M25 junction 28 improvement scheme

TR010029

8.1 Statement of Common Ground with Environment Agency

8.1 STATEMENT OF COMMON GROUND WITH ENVIRONMENT AGENCY

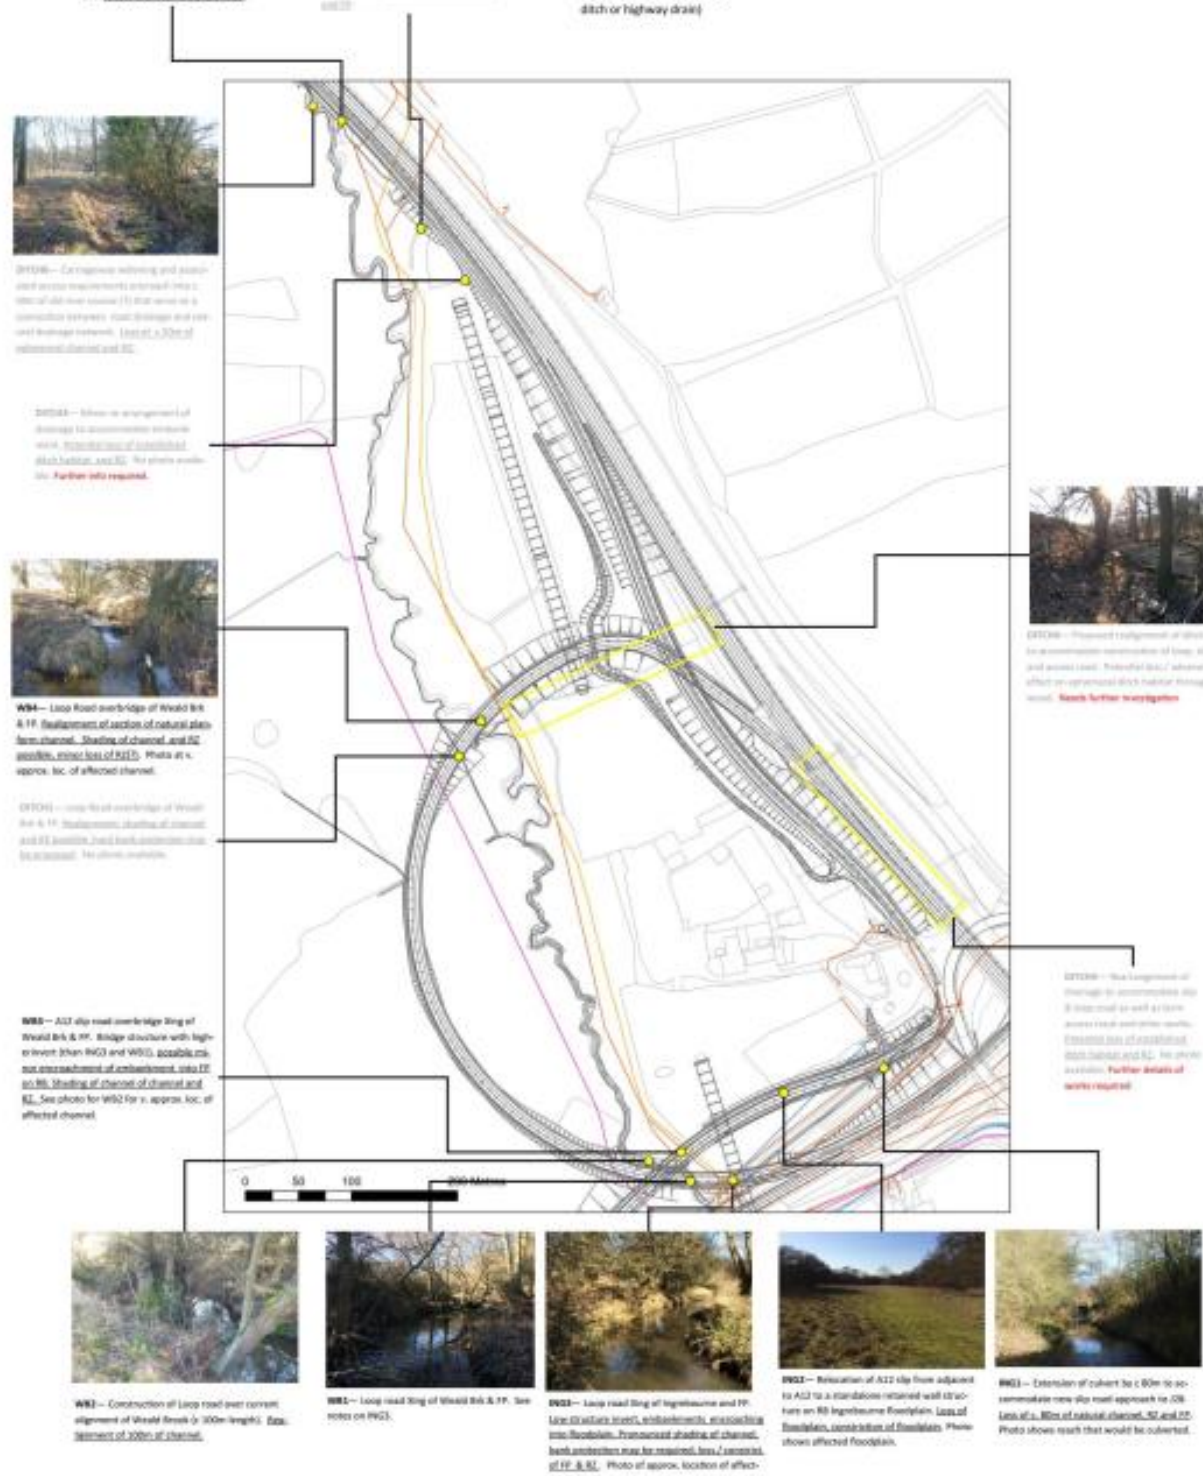
Scheme component (see fig. 1)	Name	Discussion points
	Brook and FP	<ul style="list-style-type: none"> EA asked if Atkins can investigate retaining the upstream two meanders in the proposed realignment (Action [REDACTED] – look into this design change) EA generally happy with proposed mitigation – restoration of a similar length of existing straightened channel to more natural form
WB5	Culvert extension on M25 Weald Brook Xing	<ul style="list-style-type: none"> Discussed briefly. Principles set out in "Initial thoughts from EA" for ING1 apply (though obviously at a much smaller scale, given the 8m extension here). (Action [REDACTED] – update mitigation, given that existing proposals are not adequate – can probably be included into proposed restoration elsewhere on Weald Brook)
Ditches		Not discussed at meeting (of lesser significance than effects on main river)

MIT4a,b,c	Within the restrictions defined by other constraints (most notably services, road safety and cost) structures have been set as high and wide as feasible.						Y	Y								
COMP1	Realignment of Ingrebourne, creation of backwaters, reconnection of floodplain.	Y	Y	Y	Y											Base width of channel is taken as 1m. Bankfull width taken as 9m. Channel is typically 1.5m deep
COMP2a,b,c	Ground lowering to increase floodplain storage.		Y	Y	Y											
COMP3	Riparian zone tree works to create varied light intensity, either by selected tree removal / coping or tree planting, depending on conditions.			Y	Y		Y	Y	Y							Strategic tree felling / planting to vary intensity of light reaching river and riparian zone. Different light intensities encourage different habitats.
COMP4a-e	Floodplain wetting by retaining natural surface water drainage on floodplain, or lowering floodplain.		Y	Y				Y								Wetter floodplain created by a) reducing the rate (or preventing) water draining to the river or b) scrapes to lower floodplain. Limited earth movement anticipated.

COMP5	Channel realigned with natural cross section. Additional realignment / restoration of planform of modified channel further upstream.					Y	Y									
COMP6	Realignment of c. 40m of drainage ditch into naturalised channel with scrapes.								Y							
COMP7	Restoration of planform of modified channel further downstream. Backwaters at Crossing.						Y									
COMP8	Floodplain scrape to create wetland area.										Y					
COMP9	New backwater created, returning to river 20 m downstream.													Y		
COMP10	Floodplain scrape to create wetland area.							Y								
COMP11	Floodplain scrape to create wetland area.									Y						
COMP?												?	?

Figure 1 Ingrebourne River (French's Farm)

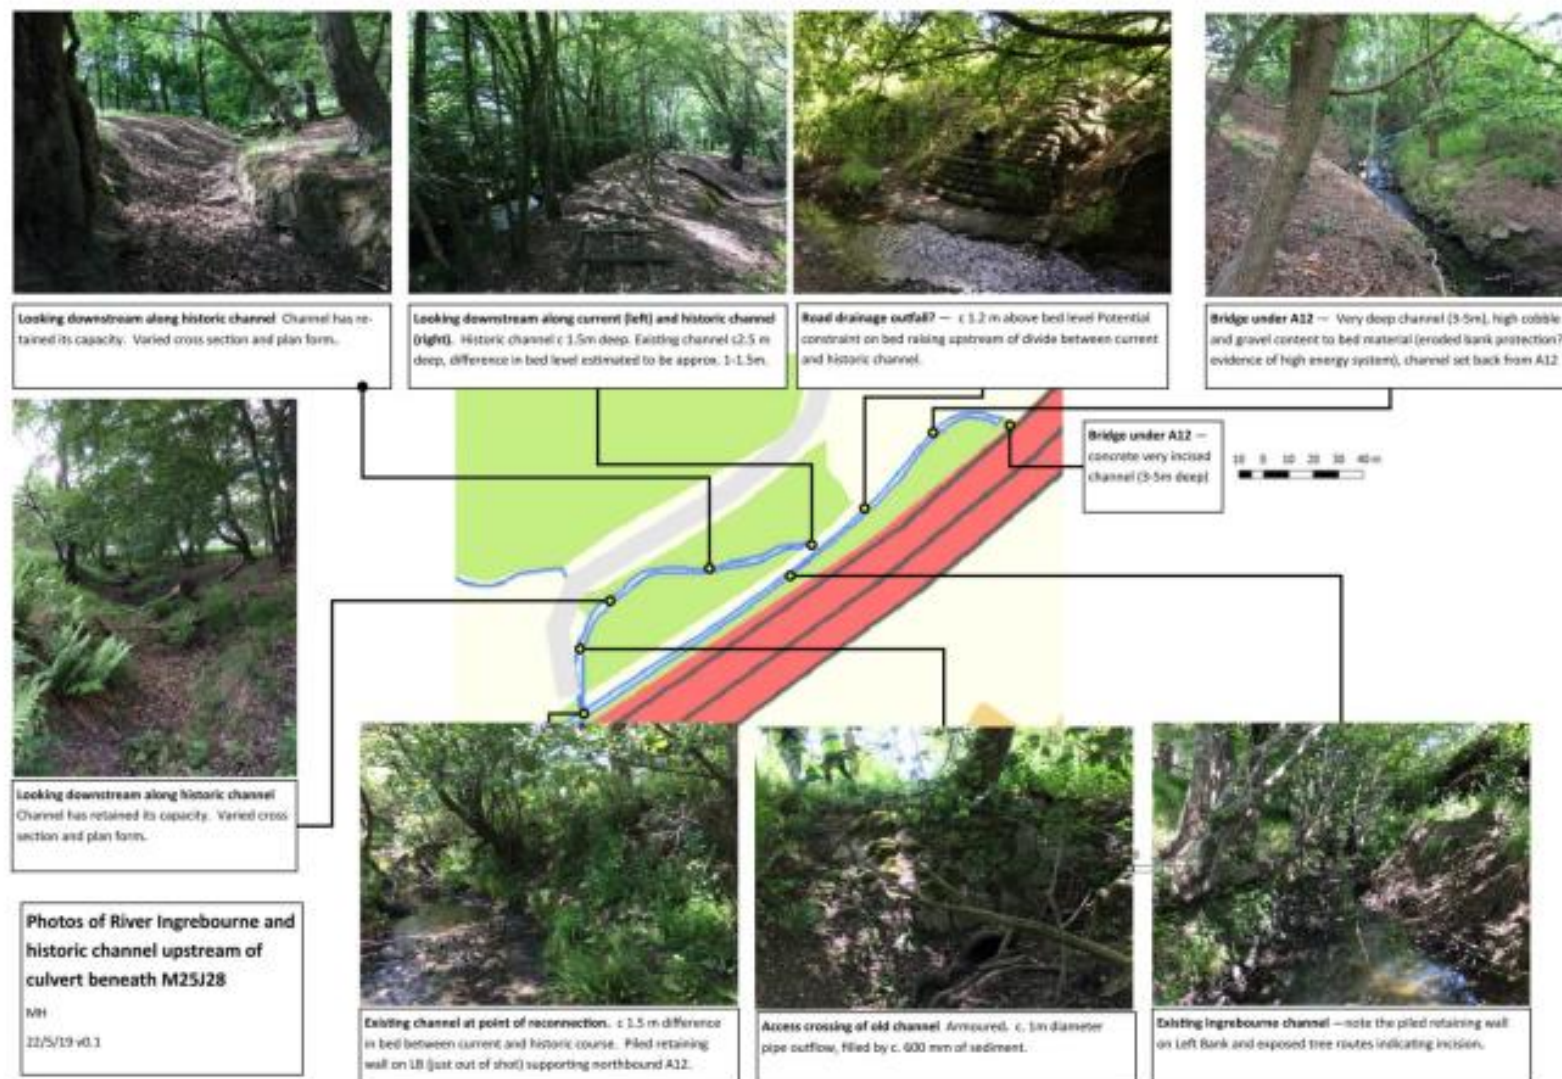
Natural geomorphological process has re-established limited sinuosity and complexity in channel cross sectional and long sectional form. For instance, along reaches with trees, incision has exposed roots and boughs of trees, creating habitat complexity. Where incision has been into mineral material, complexity has been created by deposition of side bars and runs with a substantial gravel content (see photos in Figure 1).

For this reason, the consensus during the site visit was that there was minimal ecological benefit to installing in channel restoration features along this reach of the Ingrebourne. Restoration features will achieve little more than is already developing naturally, given the substantial constraints of the deep and steep channel.

Figure 3 Action straw doll conceptual design schematic

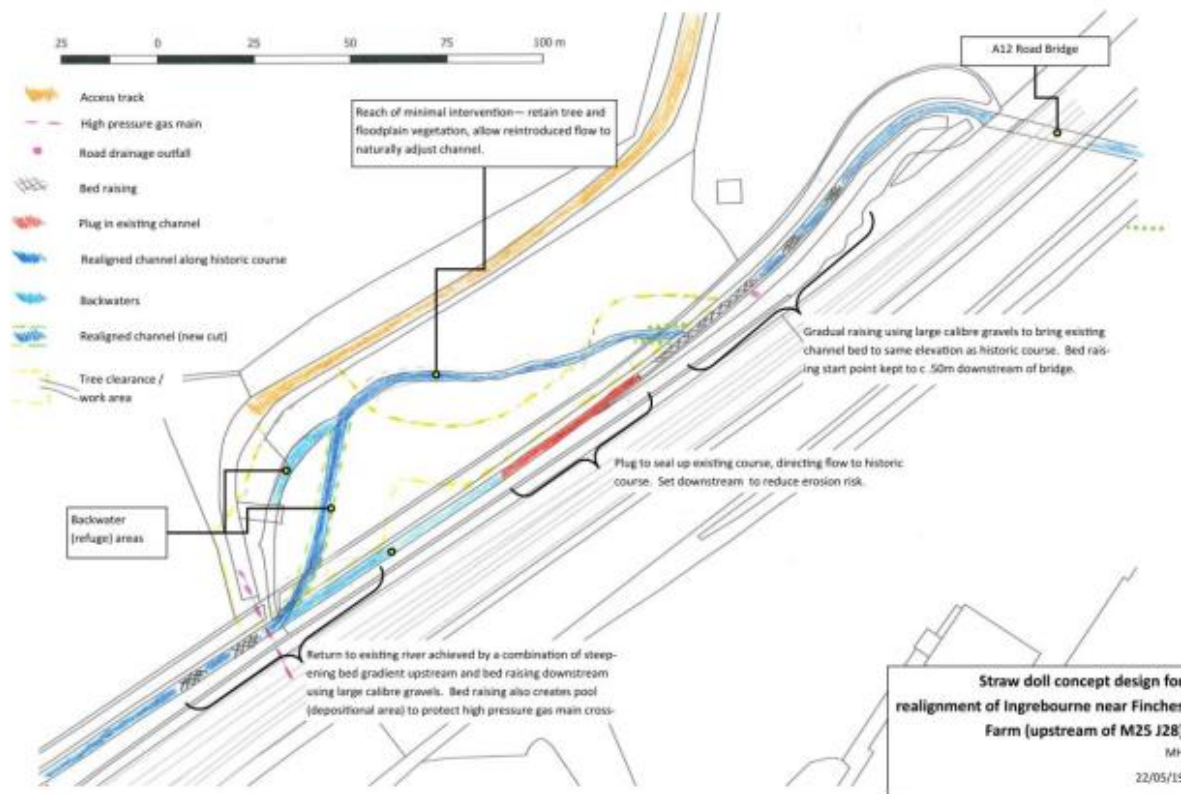
A conceptual design based on discussions during the field visit presented in Figure 3. This is intended as a starting point and a trigger for discussion on determining feasibility of this intervention

Figure 3 Action straw doll conceptual design schematic

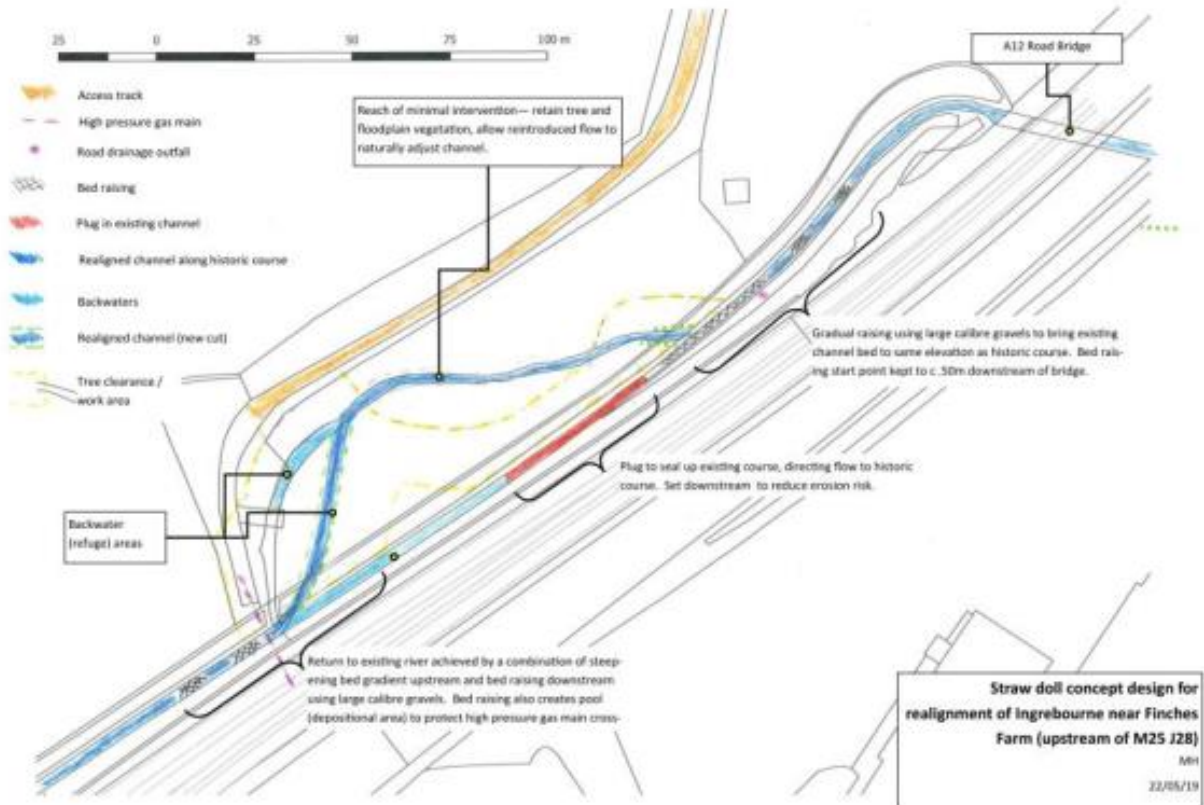
1.3. Straw doll conceptual design (Figure 3 below)
